SUMMARY REPORT
FOR

NAVAL SURFACE WARFARE CENTER, CARDEROCK DIVISION

LVS MOD DEMO VEHICLE
ARMOR PROTECTION KIT INSTALLATION

NATC PROJECT NO. 17859

PHOTOGRAPH NO. 20238-001
LVS ARMOR PROTECTION KIT
FRONT VIEW

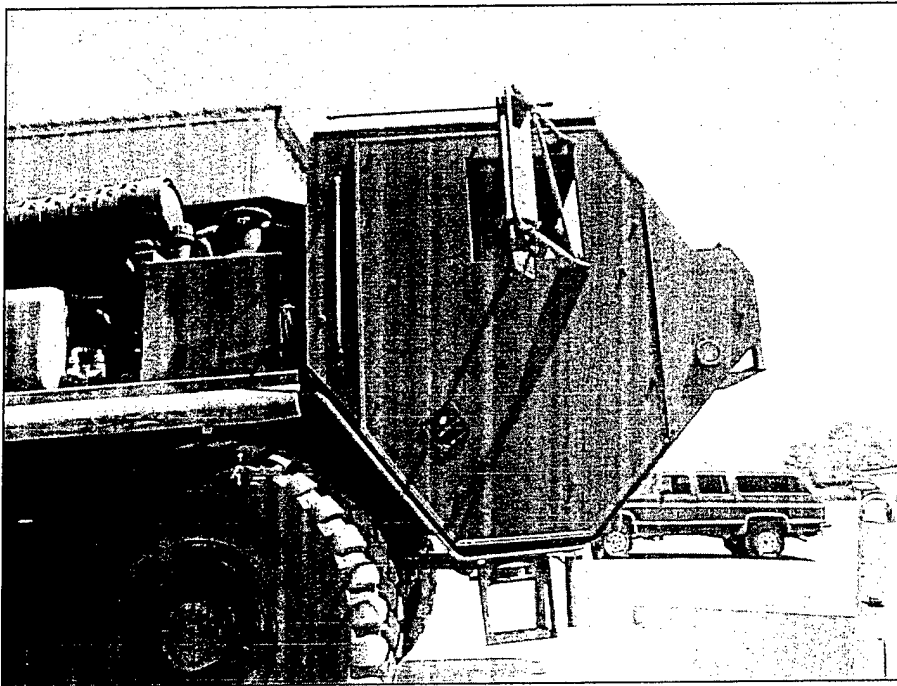
1. The black out lights were not connected through the armor kit (Photograph number 20238-001),
2. The upper clearance lights were not connected through the armor kit (Photograph number 20238-001),
3. Visibility is limited/restricted by the new cab enclosure (Photographs numbered 20238-030 and 031),
4. The air flow is restricted to the cab (Photographs numbered 20238-030 and 031),
5. The window locks may protrude into the occupant's head/body during an accident (Photograph number 20238-016),
6. The door handle (inside cab) is hard to reach next to the seat (Photographs numbered 20238-019 and 020),

7. There is no exit point for the occupants during an accident; i.e., the window can not be kicked out (Photographs numbered 20238-001 through 004),
8. The dead bolt door locks automatically lock during vehicle operation (Photographs numbered 20238-017 and 018),

PHOTOGRAPH NO. 20238-003
LVS ARMOR PROTECTION KIT
DRIVER SIDE VIEW

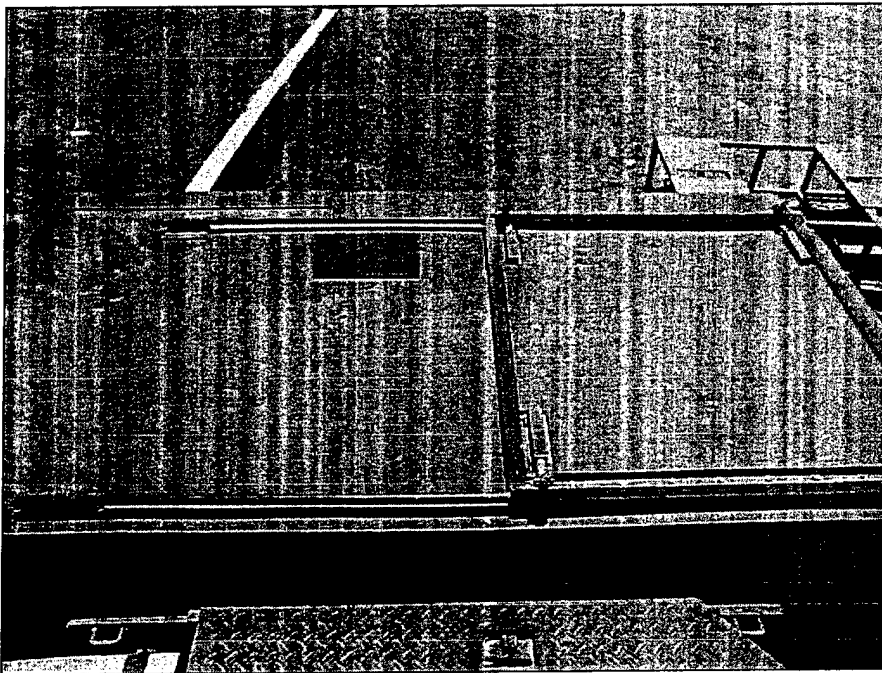
12. The underbody plate will act as a mud trap and corrosion issues are probable (Photographs numbered 20238-003 and 029),
13. The doors are too heavy for the hinges; occupants get trapped inside the vehicle due to hinges getting off track (Photograph number 20238-010),

PHOTOGRAPH NO. 20238-004
LVS ARMOR PROTECTION KIT
TOP CENTER VIEW

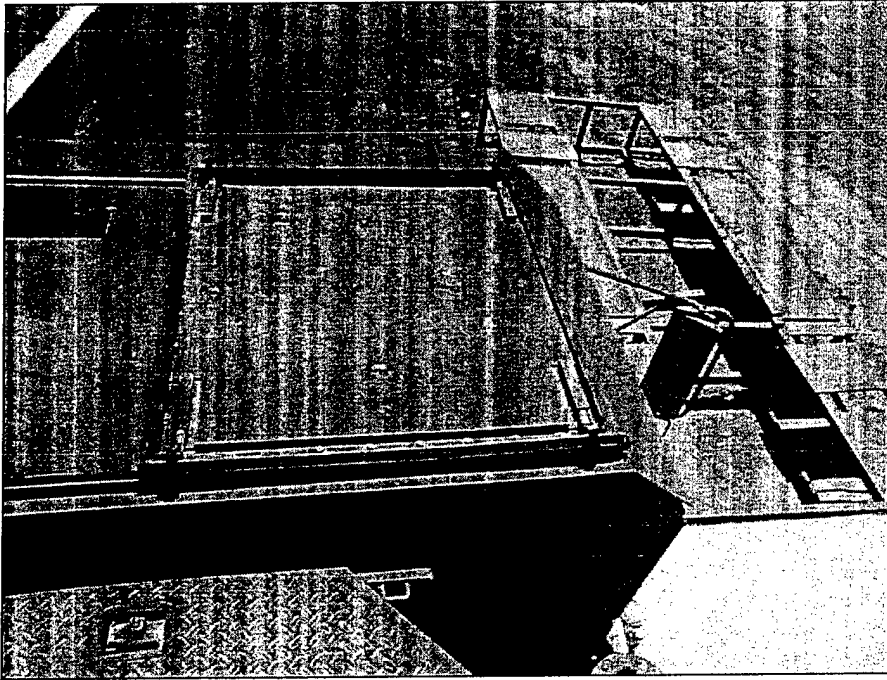
9. The bolts in the roof are protruding into the cab area creating a probability of head injury (Photographs numbered 20238-013 and 015),
10. The roof hatch is hard to lift and does not seem to slide; no 95th percentile provisions (Photographs numbered 20238-004 and 005),

PHOTOGRAPH NO. 20238-011
LVS ARMOR PROTECTION KIT
UPPER DOOR PIN LOOSE – CONTACT MARKS FROM DOOR

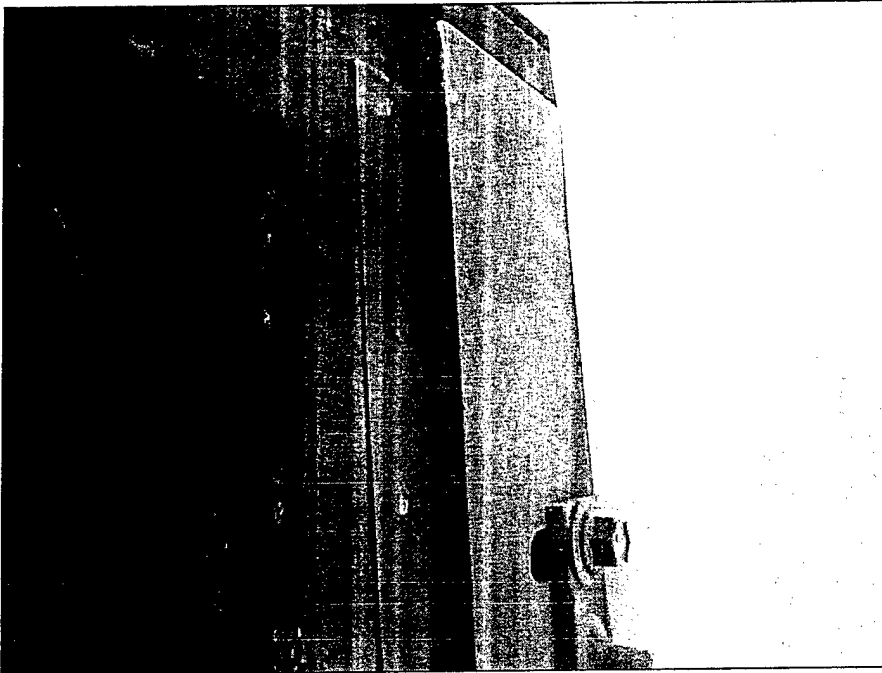
16. The driver and passenger side upper door pins are loose (Photograph number 20238-011),
17. There is a gap in the armor plate on both sides; only one bolt holds the armor kit on, the other bolt is only through the sheet metal (Photograph number 20238-012),

PHOTOGRAPH NO. 20238-014
LVS ARMOR PROTECTION KIT
PROTRUDING BOLTS BEHIND DRIVER'S SEAT

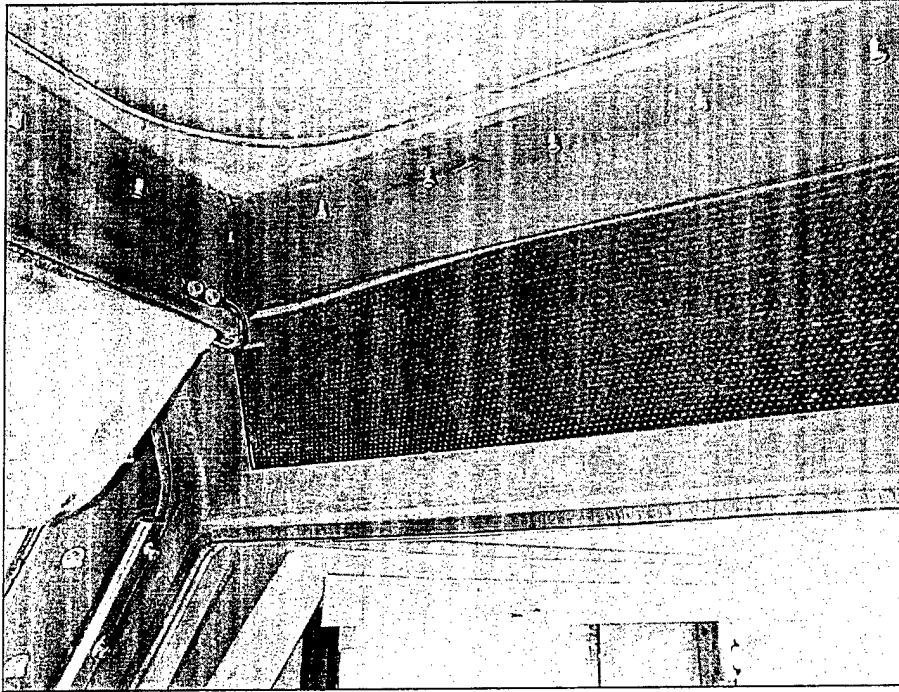
11. The entire cab has protruding bolts into the cab space creating a probability of head injuries (Photographs numbered 20238-013, 014, 015, 023, 024, 025 and 027),

PHOTOGRAPH NO. 20238-021
LVS ARMOR PROTECTION KIT
DRIVER SIDE CAB MOUNTS

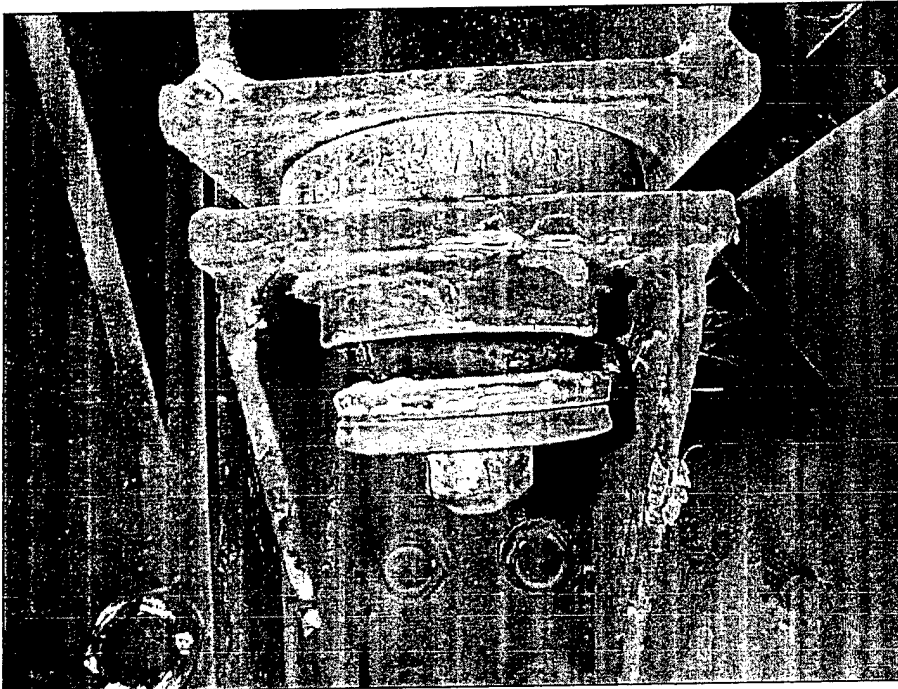
19. There is no access to clean the headlights; space will serve as a mud trap (Photograph number 20238-028), and
20. The cab mounts are deteriorating due to the additional weight (Photographs numbered 20238-021 and 022).

1. Address the twenty-one items identified should further development be merited.
2. Perform accelerated fatigue testing of the vehicle.
3. Redesign the cab mounts to consist of a stiffer material.

PHOTOGRAPH NO. 20238-024
LVS ARMOR PROTECTION KIT
PROTRUDING BOLTS PASSENGER SIDE

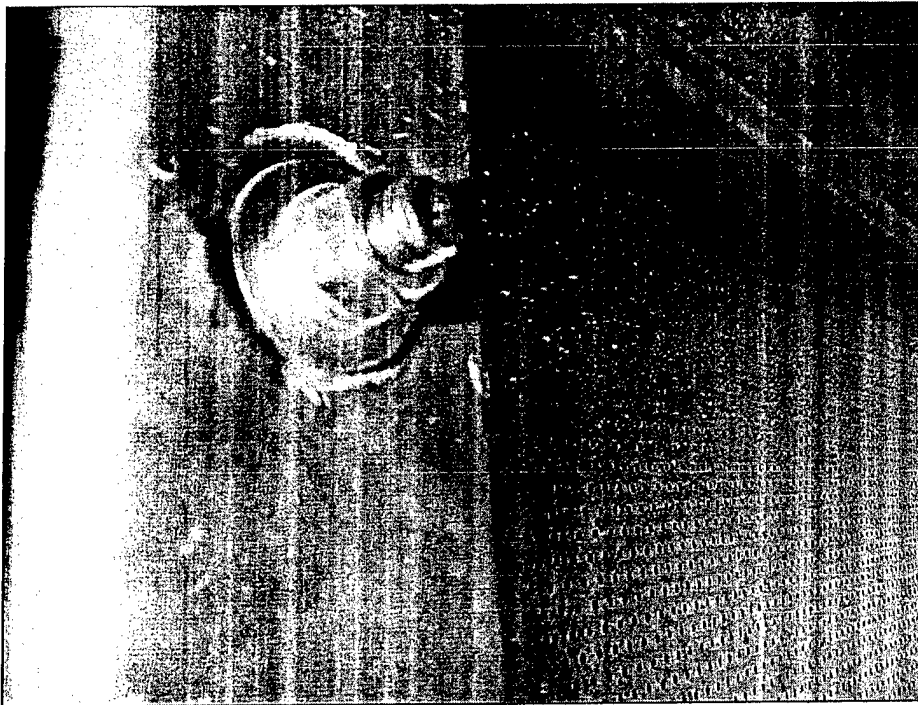
14. The armor kit is bolted through the gunner's platform; platform not operational (Photographs numbered 20238-024 and 027),
15. The cab structure tube is crushed due to no support for bolts (Photograph number 20238-025),
